Our Ref: 700102254-001

2 June 2023

Low Farm Solar Farm, Wakefield: Planning Condition 16 – Coal Mining Risk

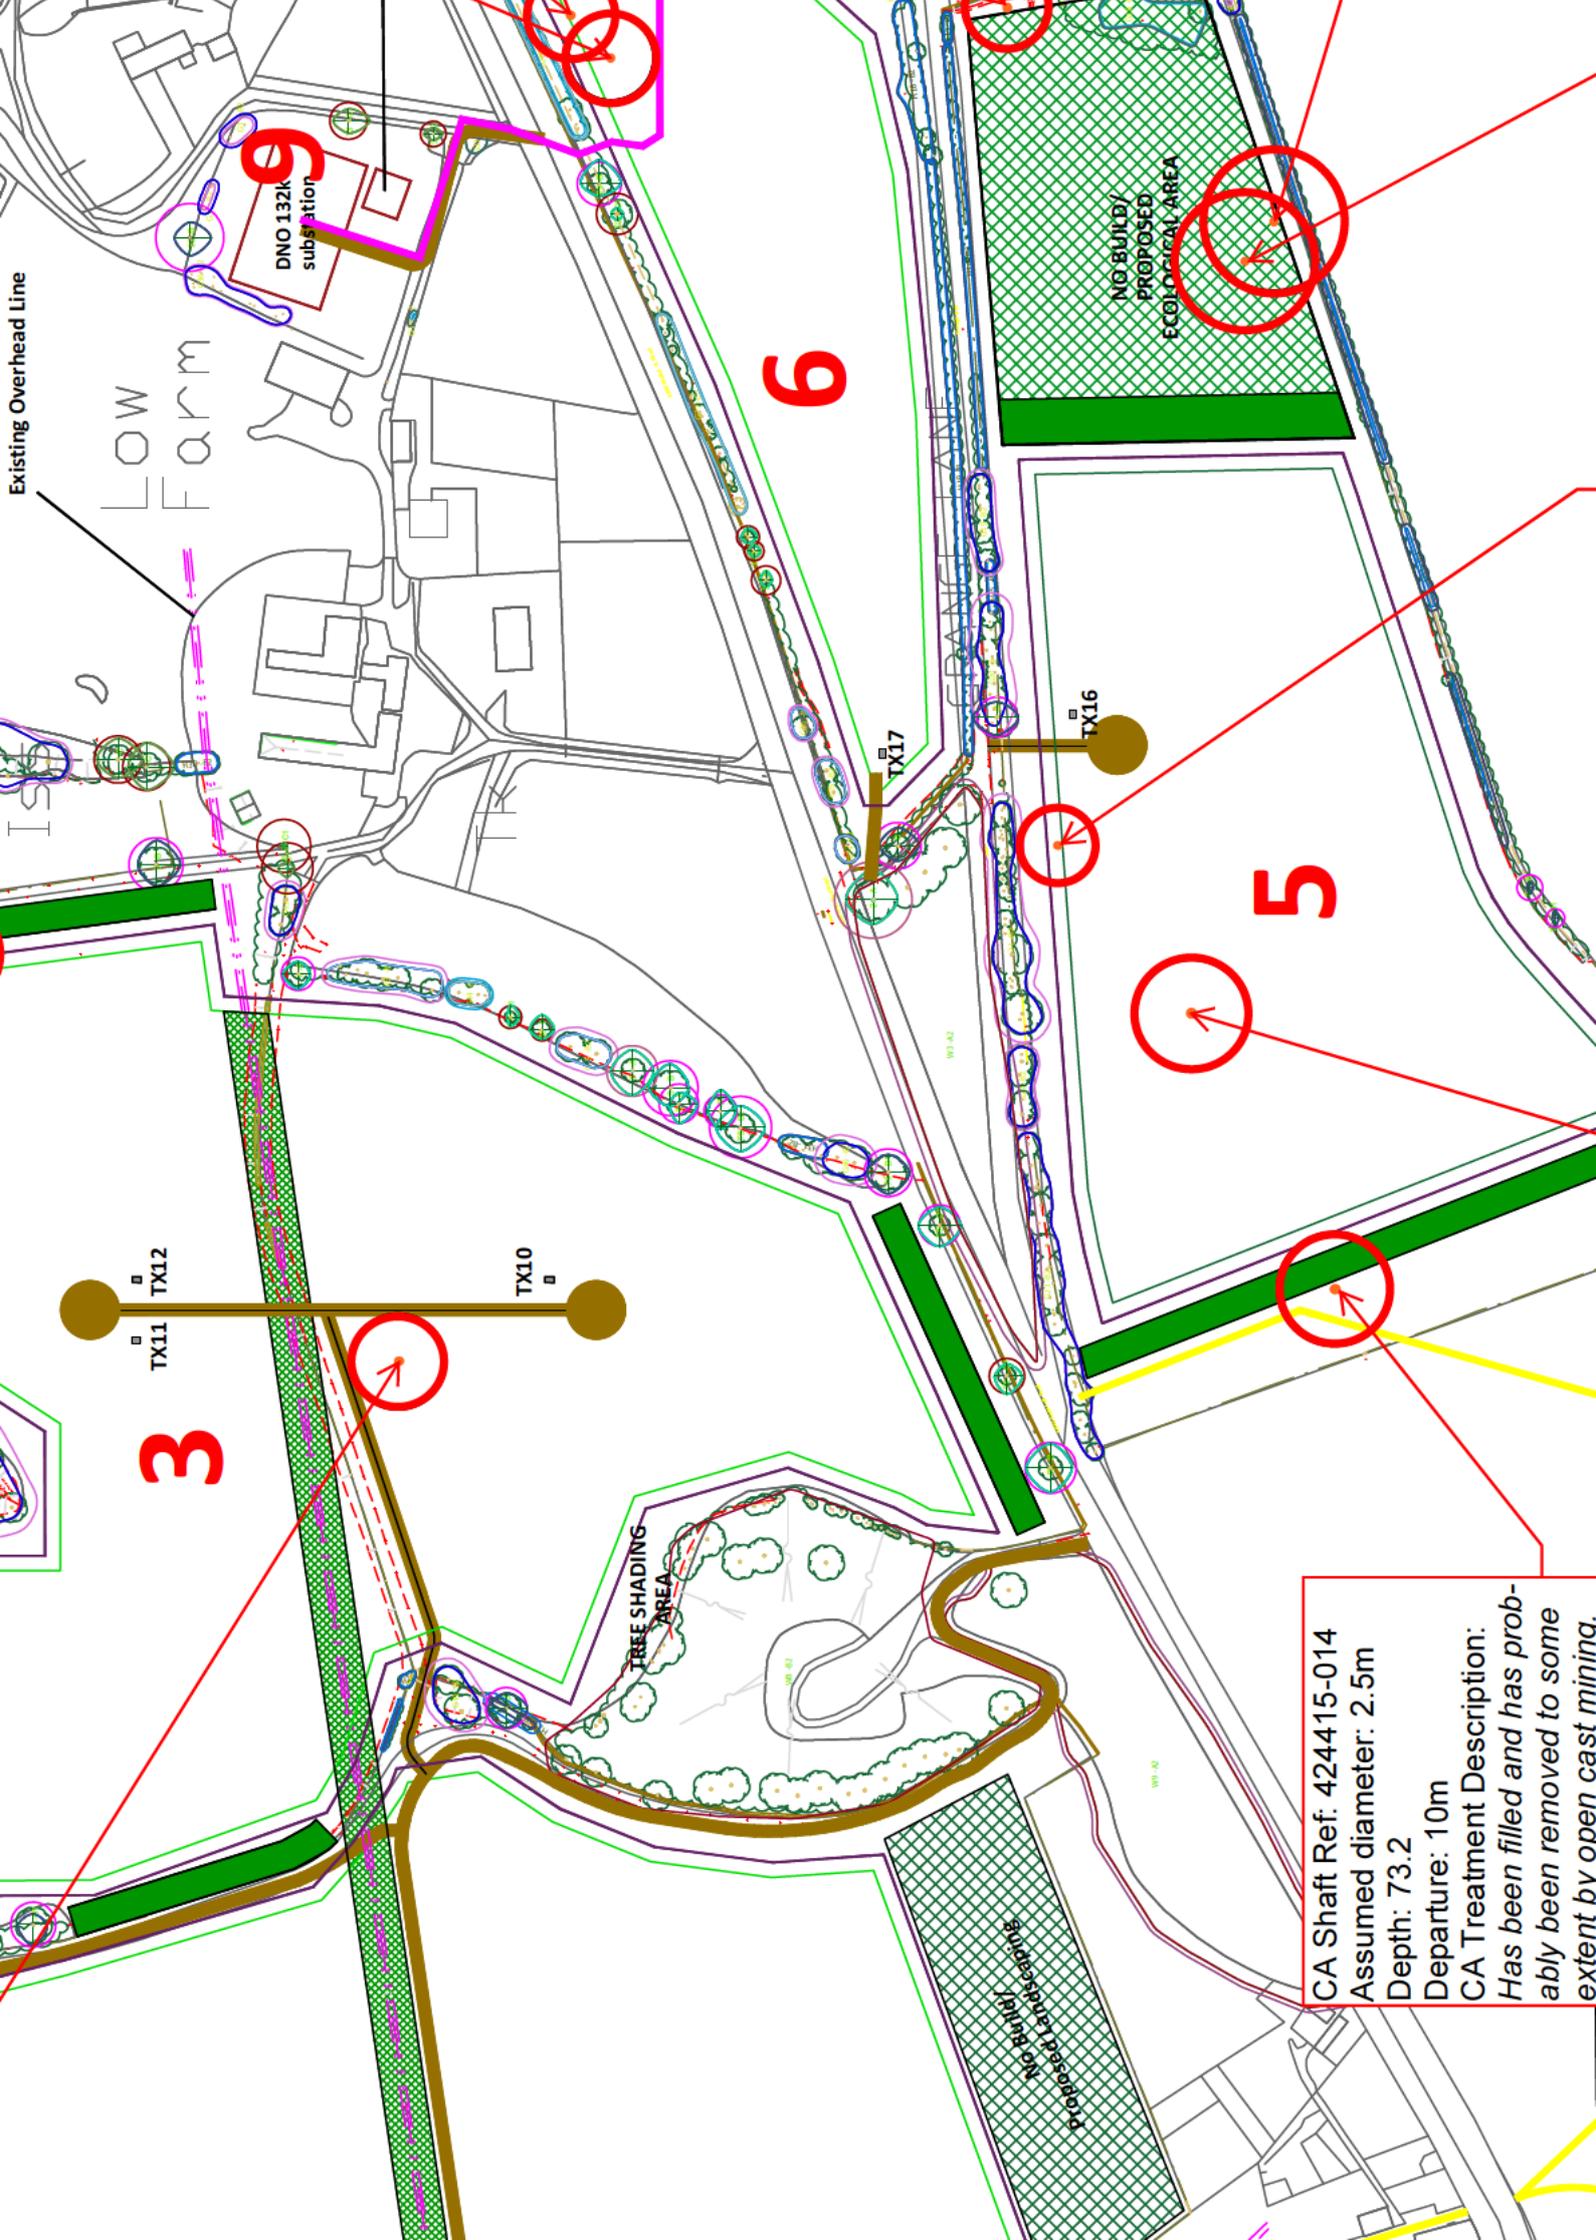
The Zols have been added to the attached drawing, showing that the proposed development masterplan has been prepared to take account of these; with key infrastructure (i.e. access roads, transformer units and substations) positioned outwith any recorded shaft Zol. It is noted that the masterplan may be altered slightly as the development design progresses. However, the intention that key infrastructure will not be located within any recorded shaft Zol is to be adhered to.

The approach of locating key infrastructure outwith any recorded shaft Zol was discussed with the Coal Authority in February 2022, as summarised in the attached email correspondence. Specifically, this included:

- The Coal Authority considering that this appears to be a pragmatic approach to managing the mining related risks by actively designing the masterplan around the areas of greater mining risk and demonstrating that each recorded shaft Zol has been considered.
- The approach should then be followed through the design documentation to allow the risks to be communicated to all site operatives (both during construction and

subsequent operation/maintenance). This includes adding a note to design drawings stating that key infrastructure is to be located outwith each recorded shaft Zol.

- On the basis of this approach, intrusive ground investigation to inform the risk associated with the mine shafts would no longer be a requirement for planning.
- Given the risks associated with the mine shafts in this instance, it appears appropriate to found solar panels within any recorded shaft Zol, with other infrastructure located outwith any recorded shaft Zol.

Taking into consideration the nature of the development and your recommendations within your email of the 16 February 2022, based on your extensive review of the coal mining legacy affecting the site and the mitigation measures identified, subject to the applicant affording due consideration to your recommendations, this appears to be a pragmatic approach to take, in this particular instance.
